DEVIATION REQUEST AND DECISION FORM

Project Name :	Winsome Filing No 1
Schedule No.(s) :	Existing Right of Way
Legal Description :	Same

- **Table 2-32 Minimum Curb Return Radius at Intersections (Rural Roads)**

WINSOME FILING NO. 1
EL PASO COUNTY, COLORADO
CONSTRUCTION DOCUMENTS
WB-50 TURNING TEMPLATE

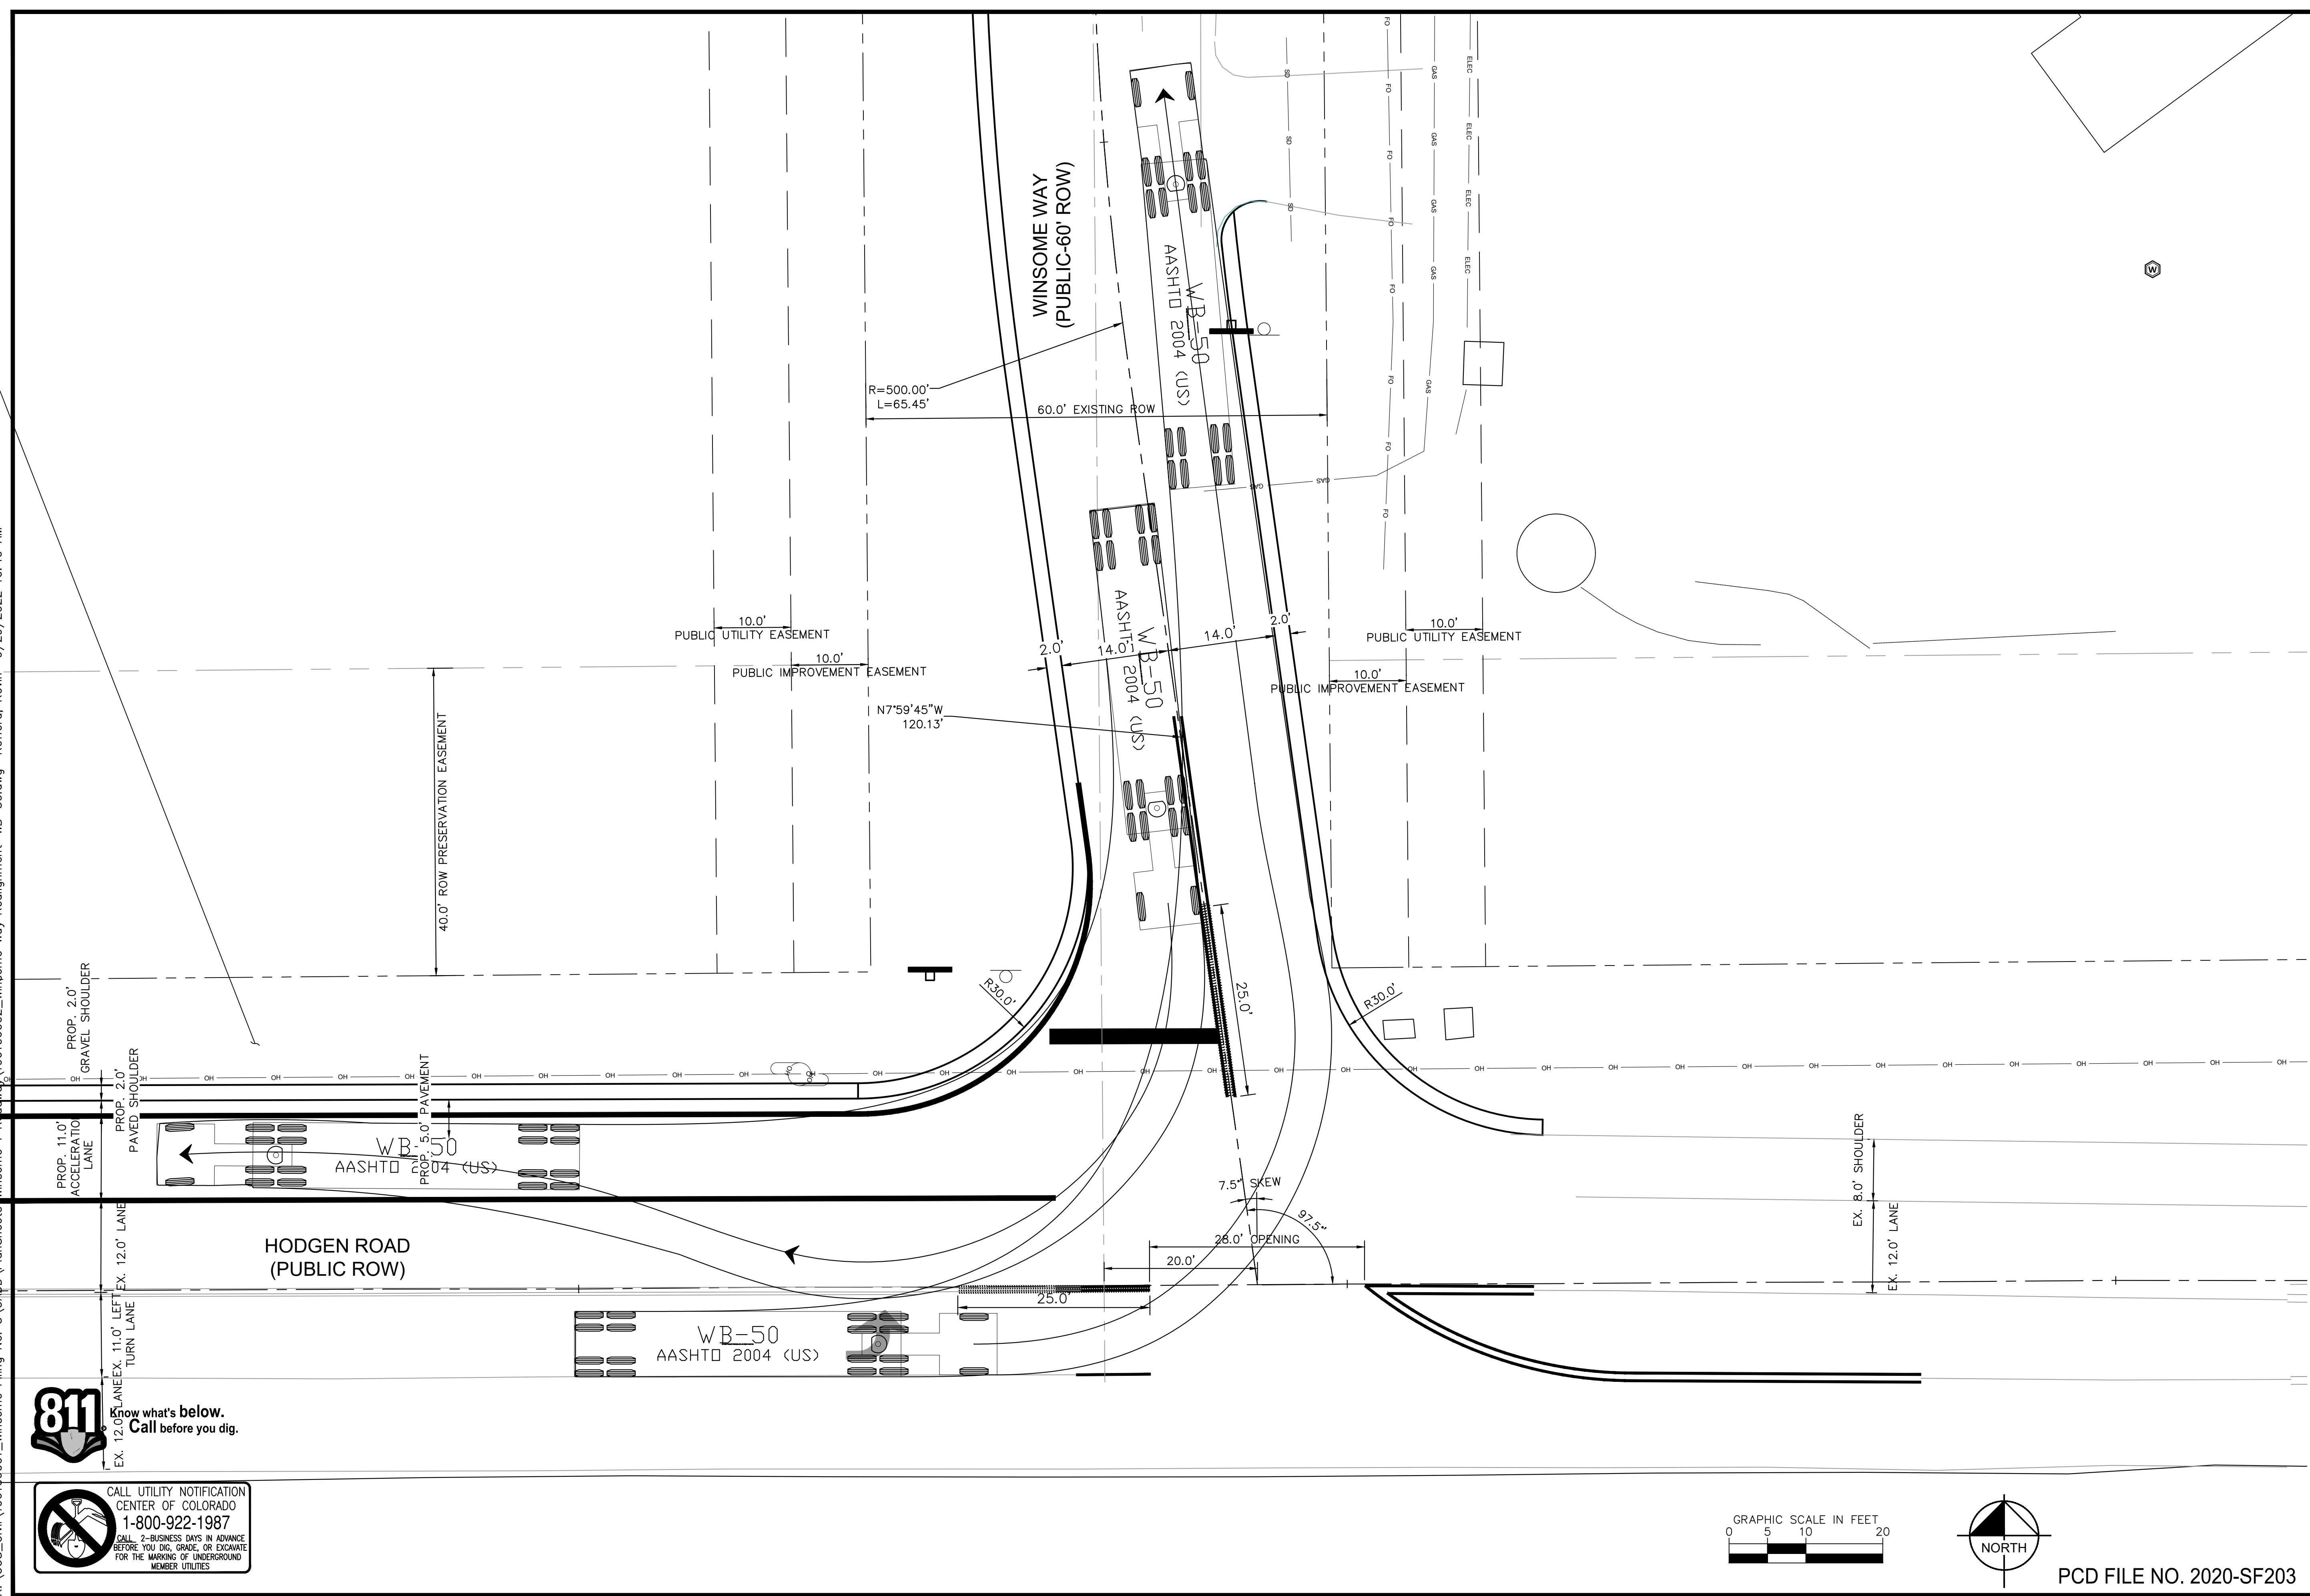
- The proposed alternative is to allow 30 feet radius on both sides of the intersection of Winsome Way with Hodgen Road.

- The proposed alternative allows better clearance from existing utilities. On the west side of the intersection is an overhead power pole. On the east side of the intersection is an existing telephone vault and a communications pedestal.

- A WB-50 design vehicle can safely navigate the proposed 30 feet radius.
[as shown on the attached Exhibit](#)

- The proposed 30 feet radius provides clearance from existing utilities which allows safer operations of the roadway.
[as shown on the attached Exhibit](#)
